# NORTH TEXAS MUNICIPAL WATER DISTRICT

## LAKE SIDE INTERCEPTOR REPLACEMENT

PROJECT NO. SRWWPCF 07-1(102)

### CONFORMED SET

**PLAN AND PROFILE**  
 STA. 34+00 TO STA. 39+00

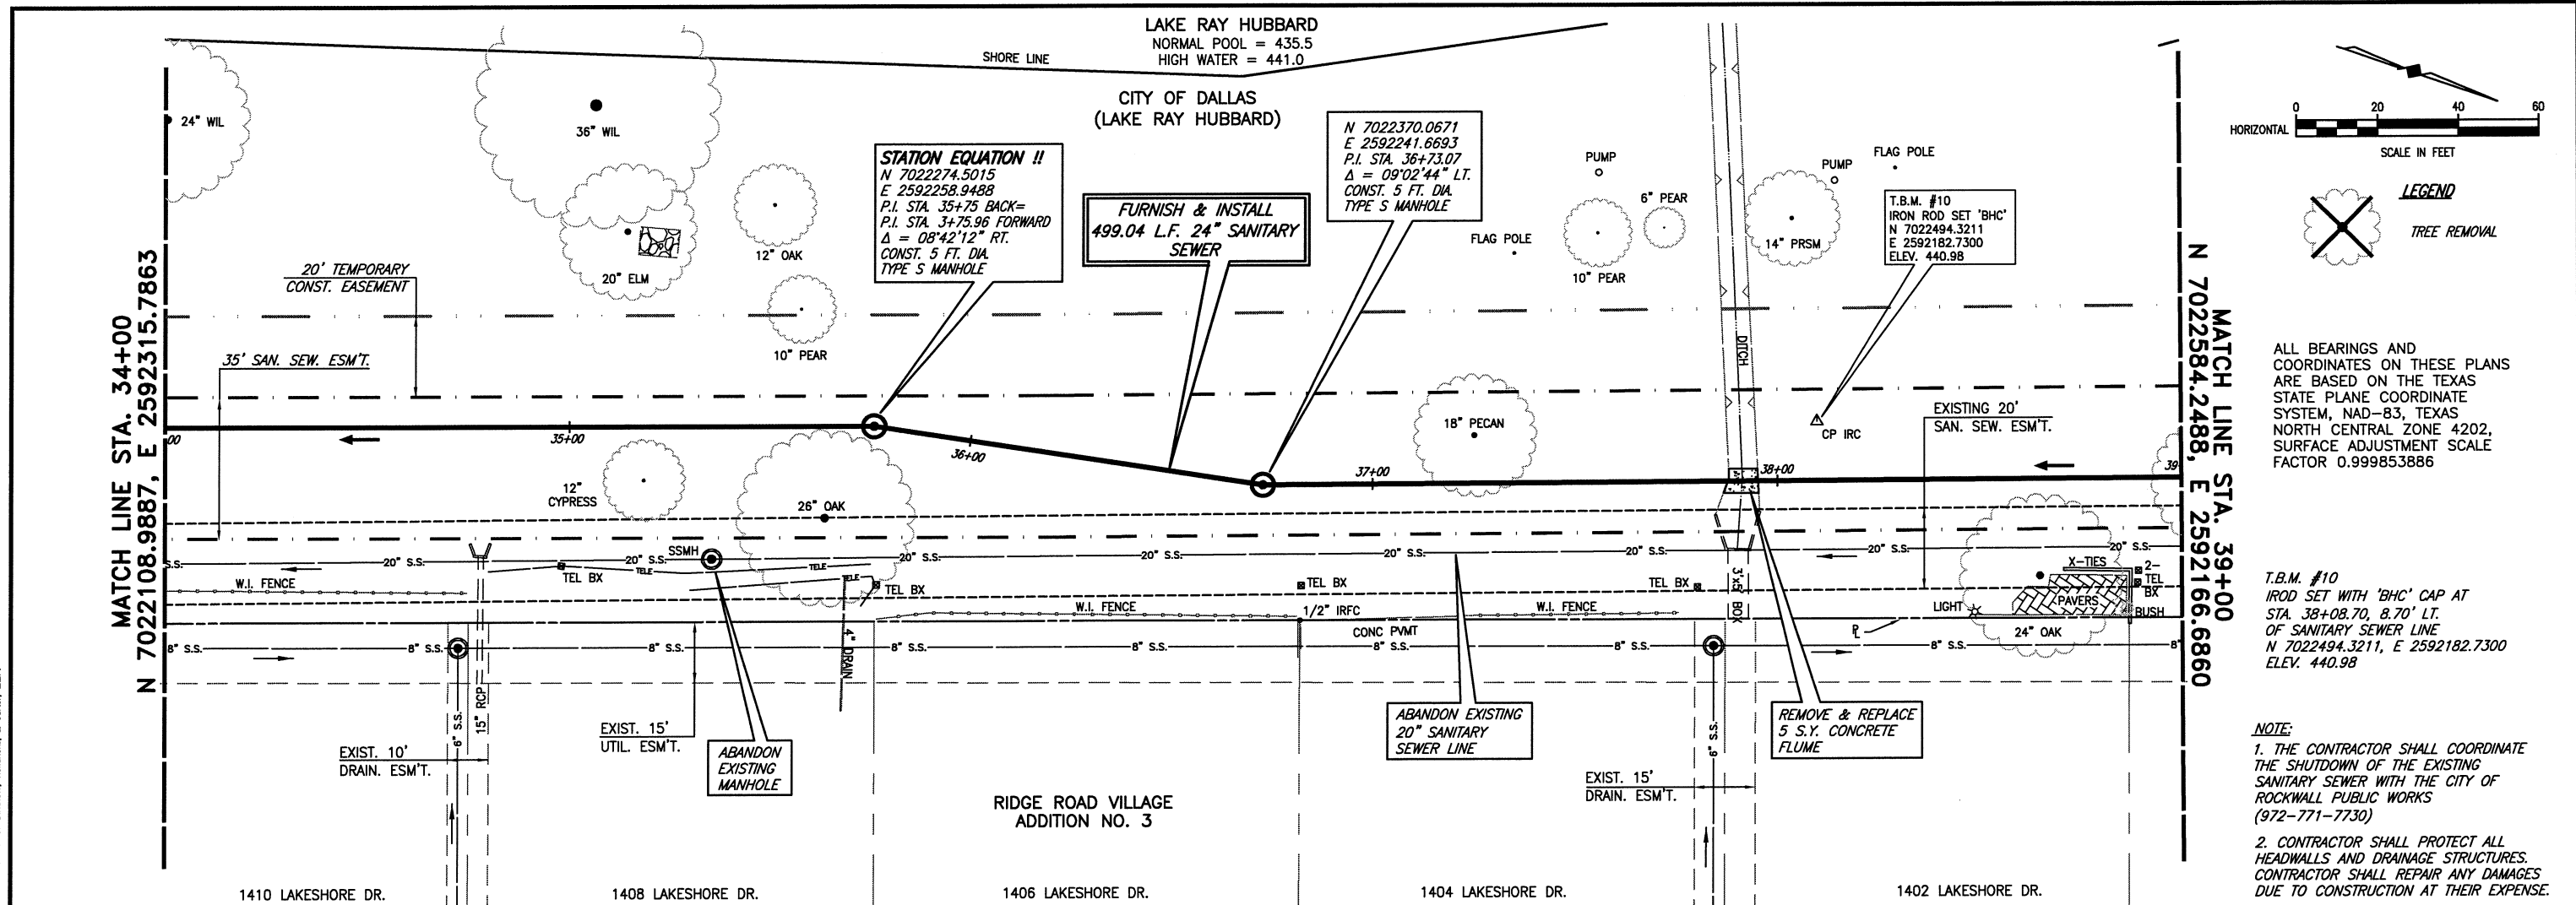
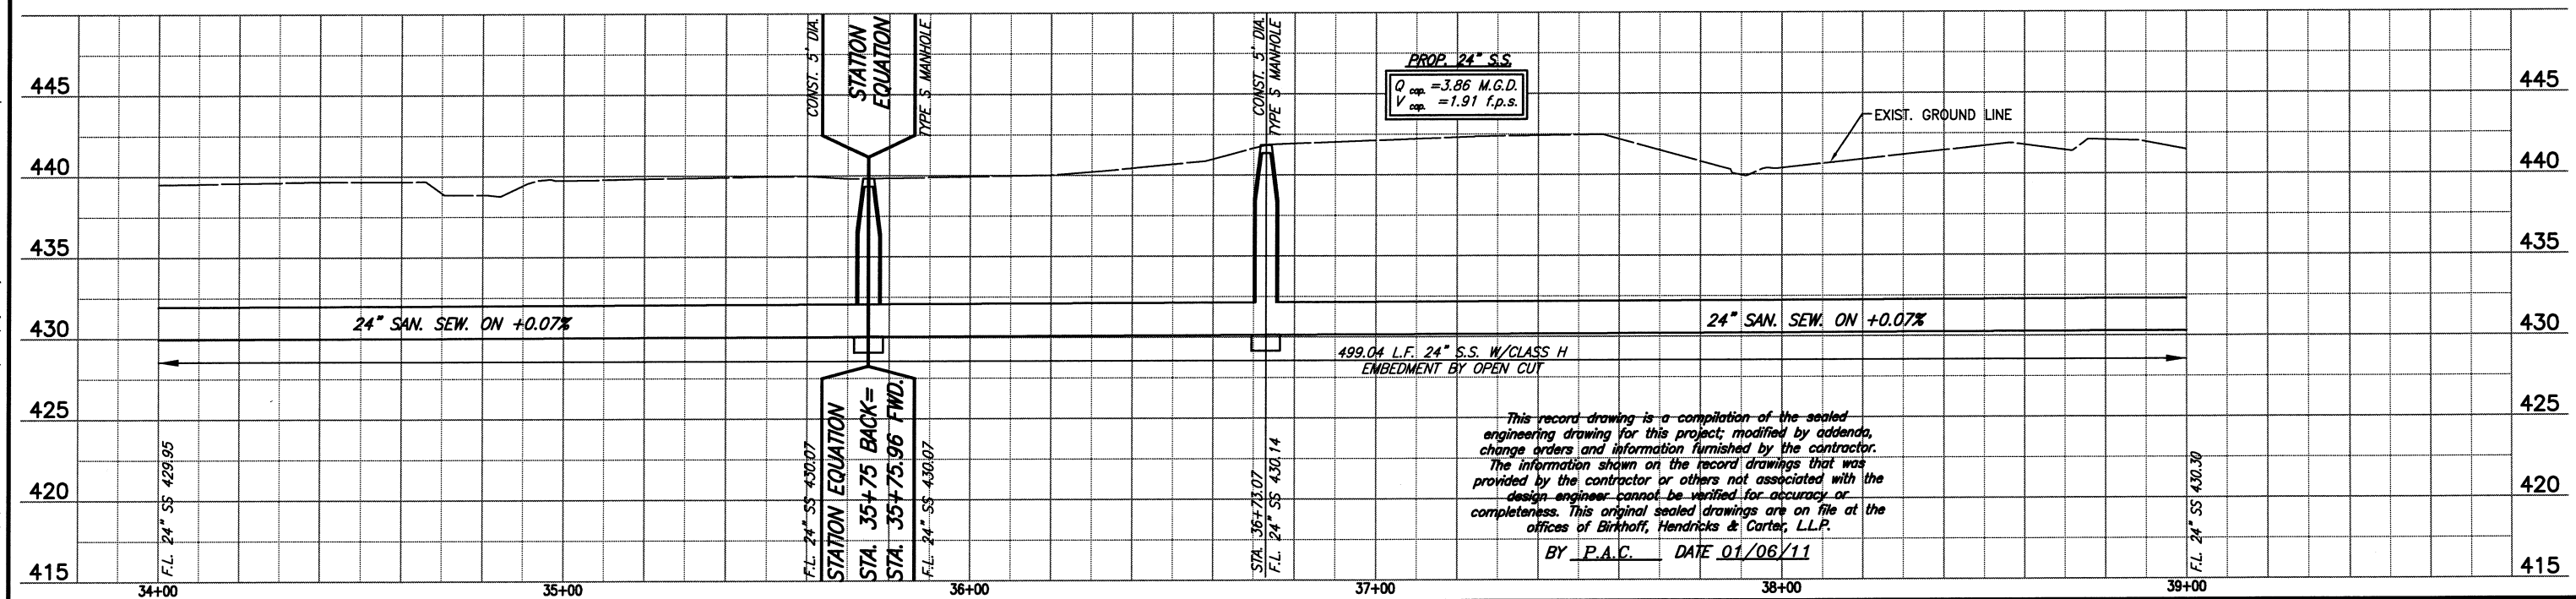
CHANGE ORDER NO.1 2/12/09 - REVISED BORE LOCATIONS & ENCASEMENT
FIELD CHANGE NO.4 6/29/09 - REVISED VERTICAL ALIGNMENT

**PLAN AND PROFILE**  
 STA. 39+00 TO STA. 44+00

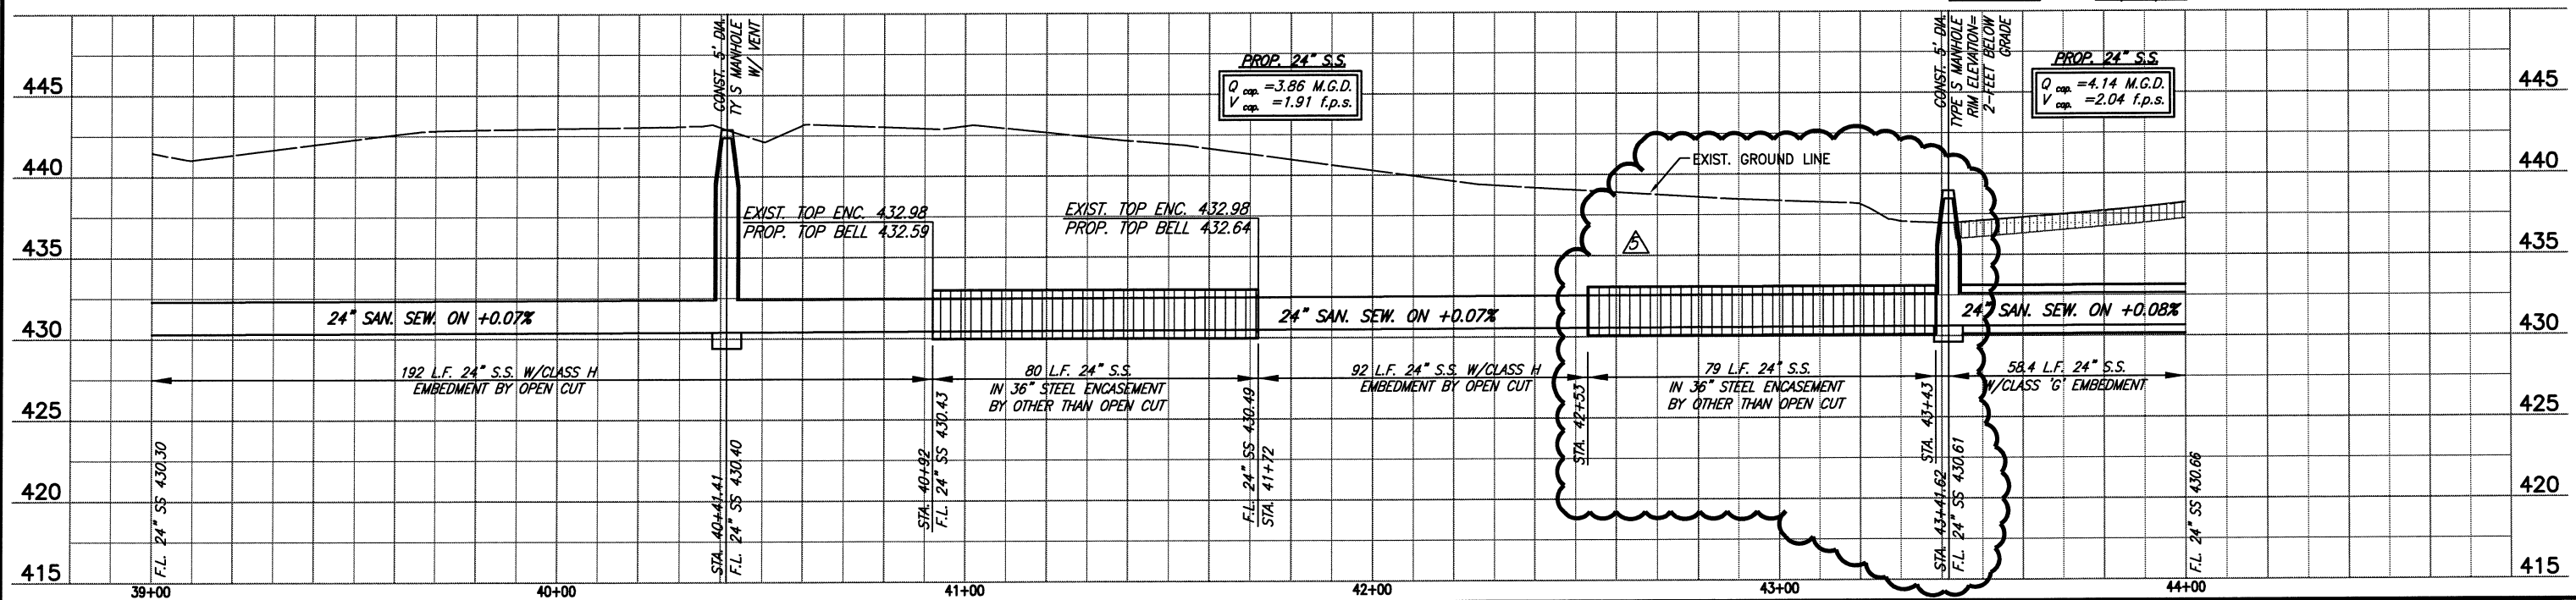
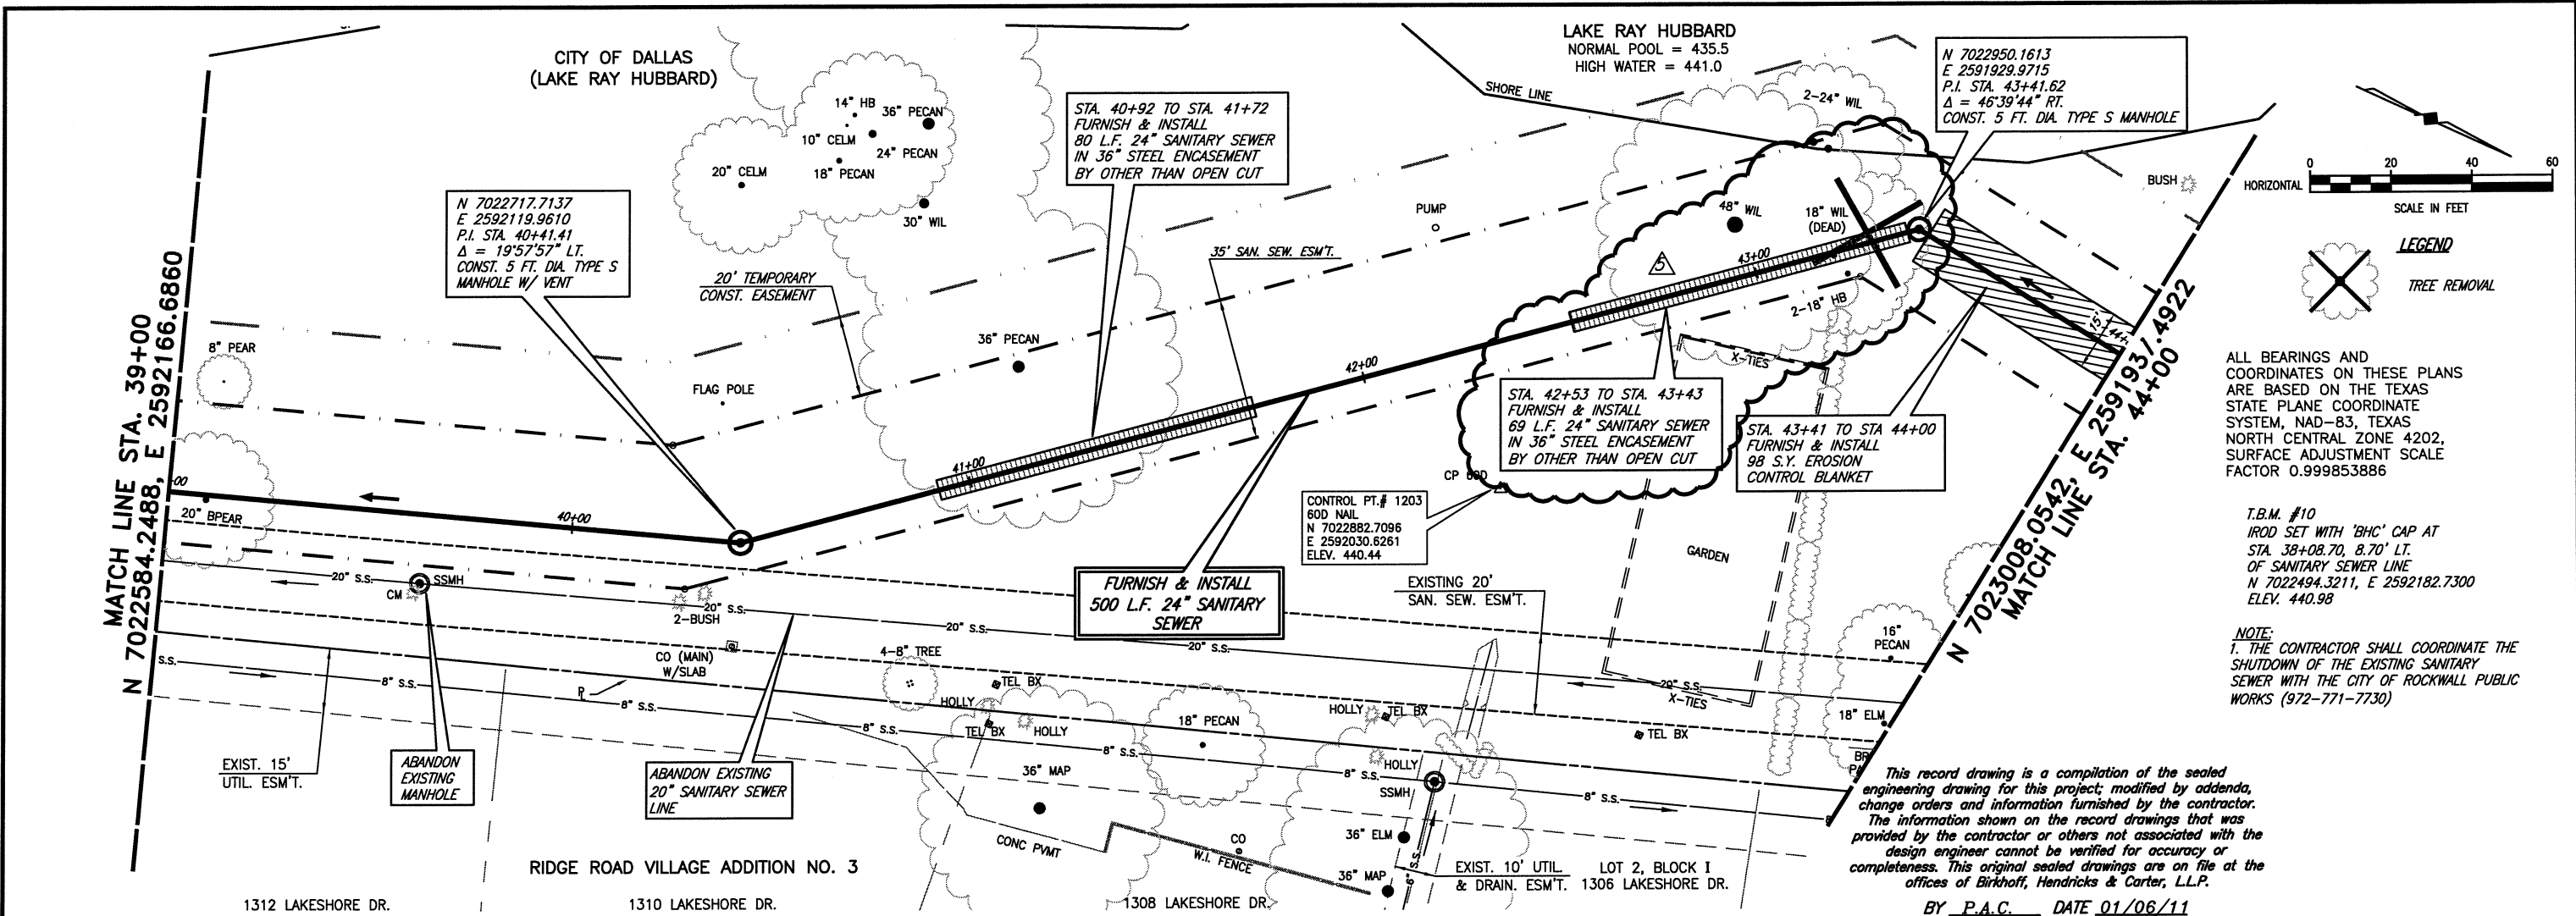
CHANGE ORDER NO.1 2/12/09 - REVISED BORE LOCATIONS & ENCASEMENT
FIELD CHANGE NO.4 6/29/09 - REVISED VERTICAL ALIGNMENT
FIELD CHANGE NO.5 8/2009 - EXTENDED BORE
